Product Change Notification / SYST-09WTKU988

ERRATA - PIC32MM0256GPM064 Family Silicon Errata and Data Sheet Clarification

PIC32MM0256GPM064 Family Silicon Errata and Data Sheet Clarification

2. Module: Pin Diagrams: 48-Pin UQFN, TQFP

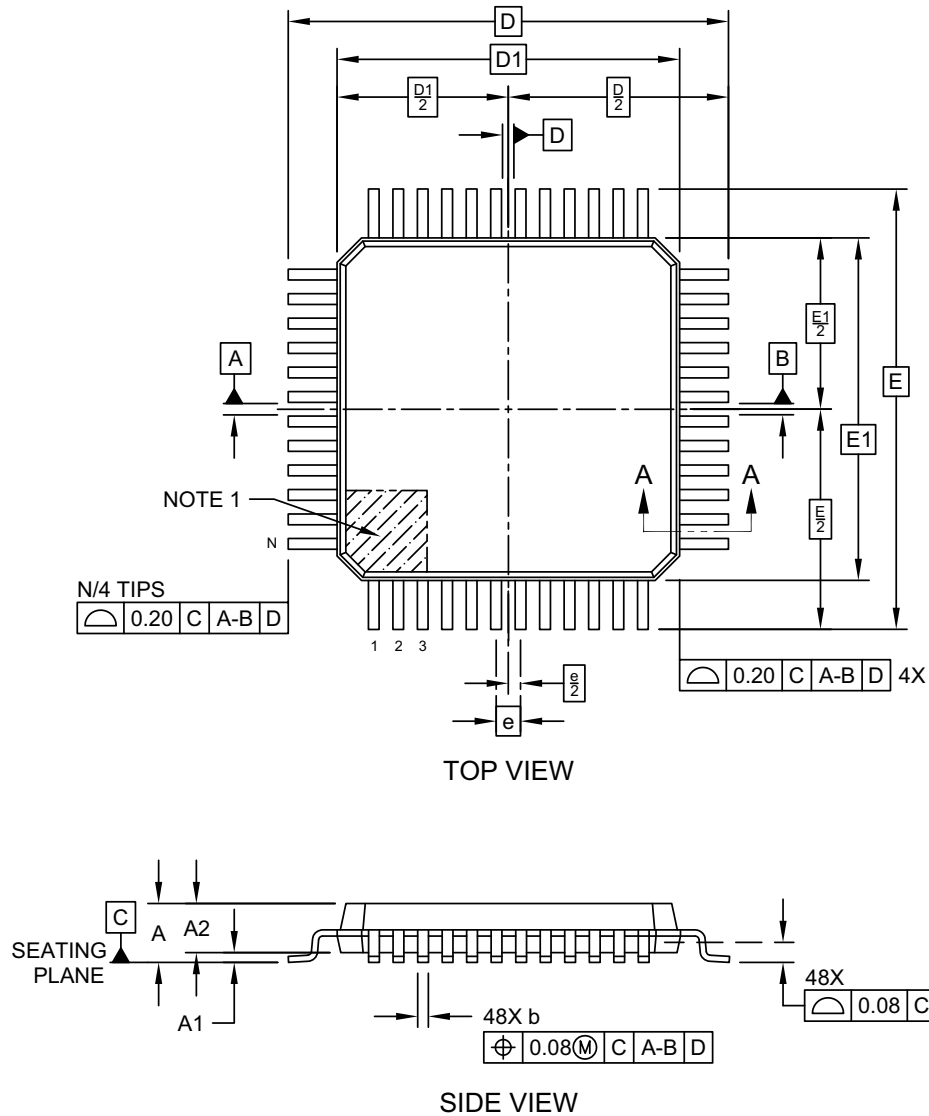
Note 3 is applicable for the 48-pin UQFN package only. The Thermal pad is not available on the 48-pin TQFP Package.

48-Lead Plastic Thin Quad Flatpack (Y8X) - 7x7x1.0 mm Body [TQFP]

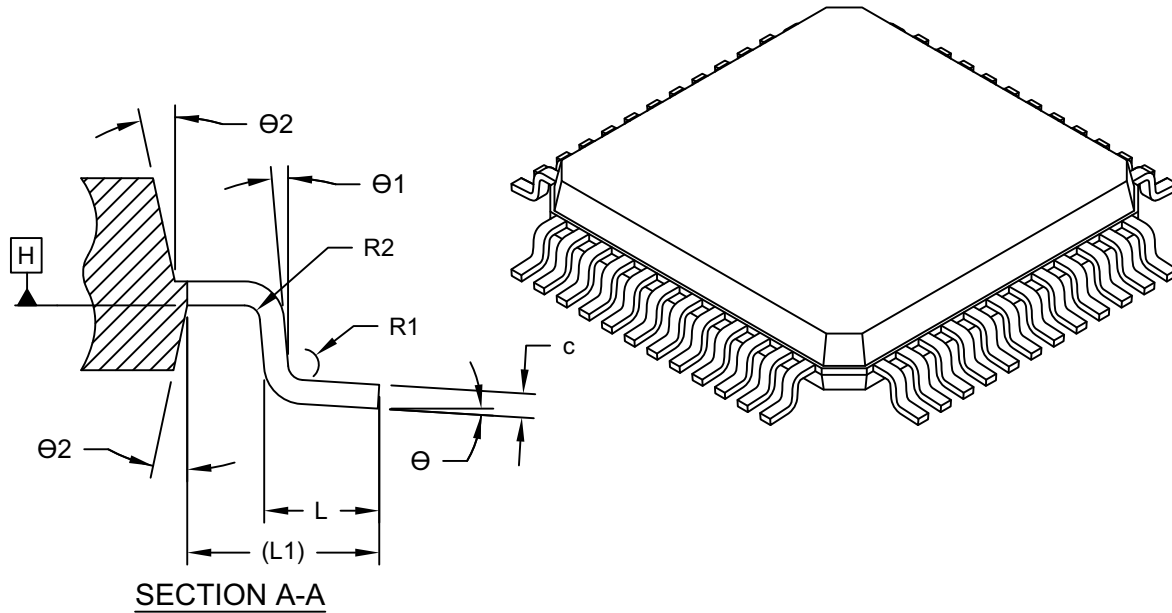
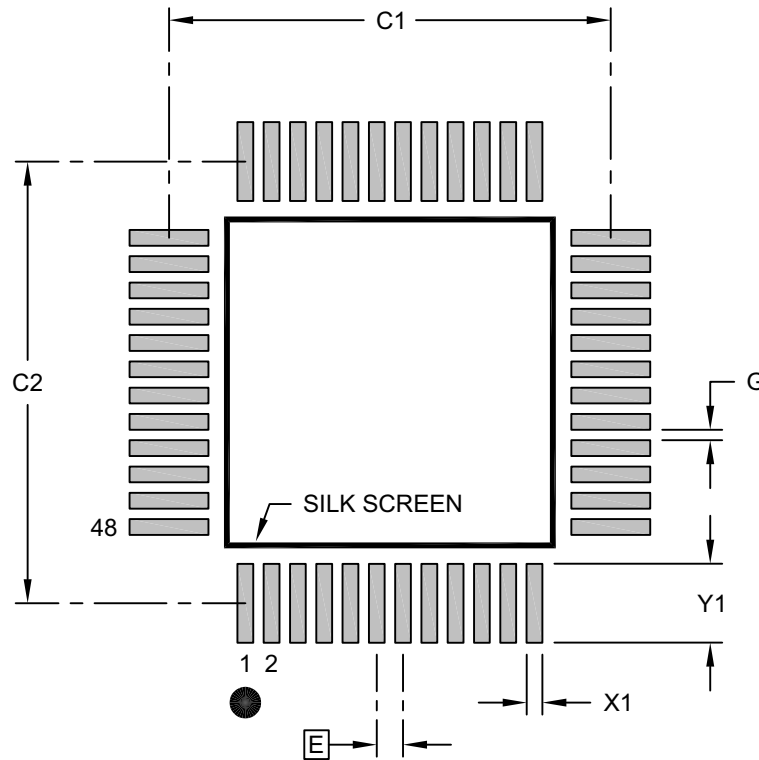
3. Module: Package Details/Drawing: 48-Pin TQFP

The following figure shows the updated package drawing for the 48-Pin TQFP Device:

4. Module: Pin Diagrams: 64-Pin QFN, TQFP

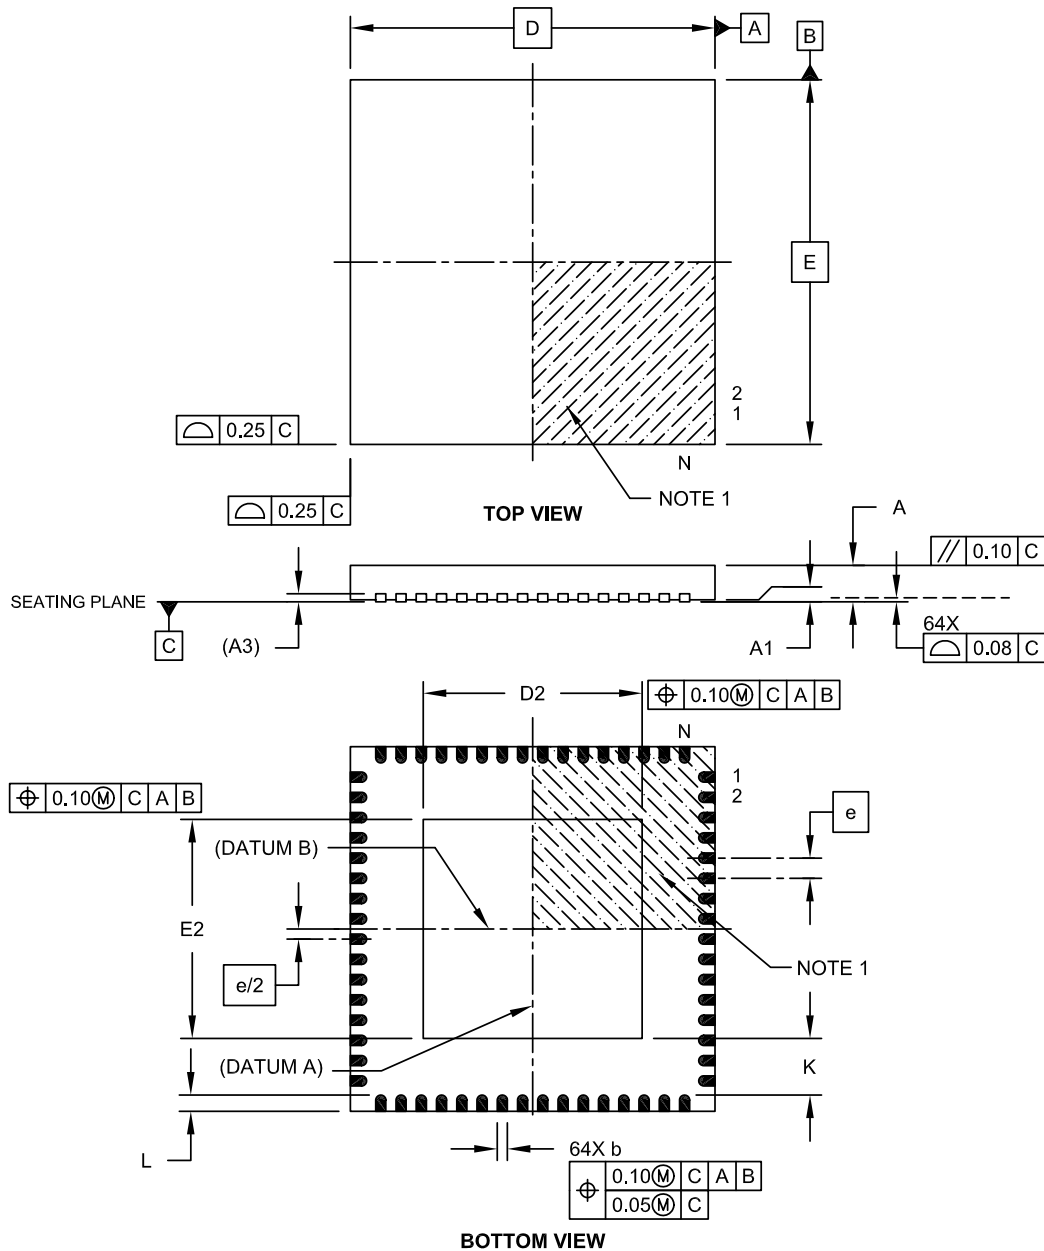
Note 3 is applicable for the 64-pin QFN package only. The Thermal pad is not available on the 64-Pin TQFP package.

64-Lead Plastic Quad Flat, No Lead Package (MR) – 9x9x0.9 mm Body with 5.40 x 5.40 Exposed Pad [QFN]

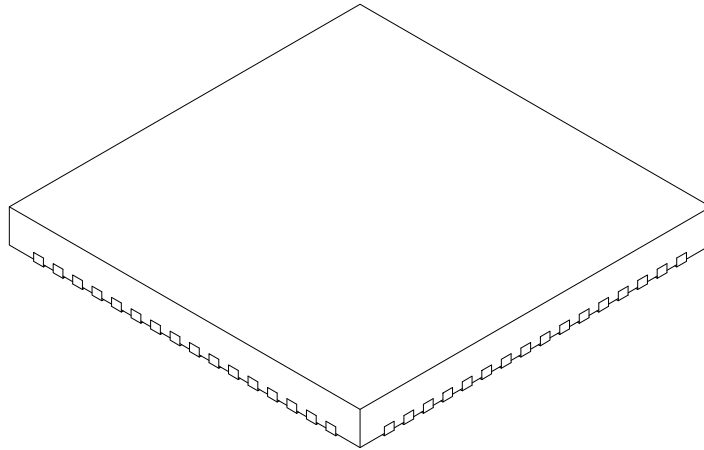
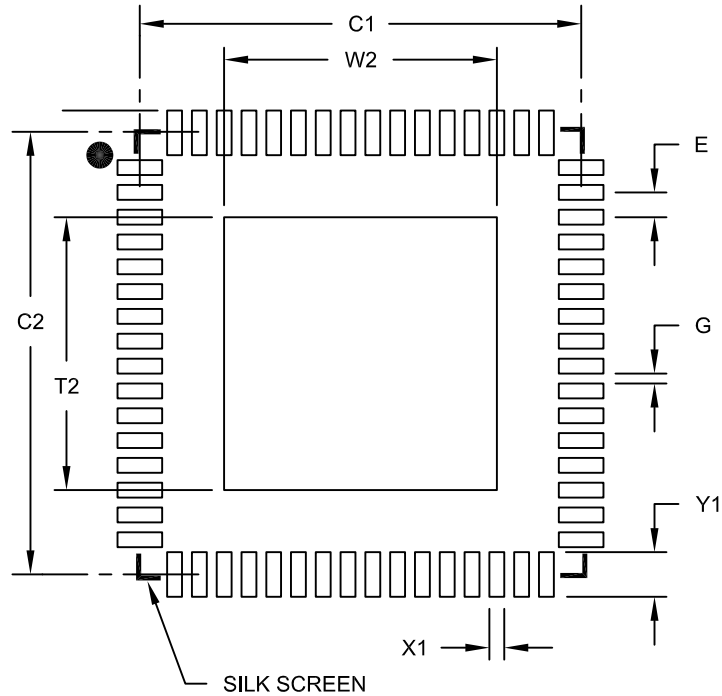
5. Module: Package Details/Drawing: 64-Pin QFN

The following figure shows the updated package drawing for the 64-Pin QFN device.
